4981A-11

S E R V I C E N O T E

HP 4981A Network Advisor

Monochrome LED Board Modification (NOT Color)

J2176-66502 LED Board Assembly

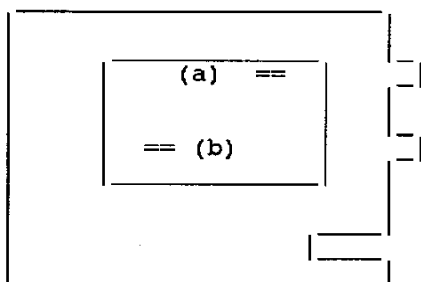
When new monochrome assembly 5063-1880 is required to replace the older 5062-9677 display, the LED board must be modified. The modification will allow a greater range of brightness adjustment.

1. Remove fastener(s)
2. Disconnect jumper wires

3. Carefully snap out LED display board assembly
4. Locate jumper and remove at one of either location as shown in the diagram

Jumper locations  
(a) or (b) is on  
the small board.

5. Reinstall wires/fasteners and board assembly
6. Test brightness operation
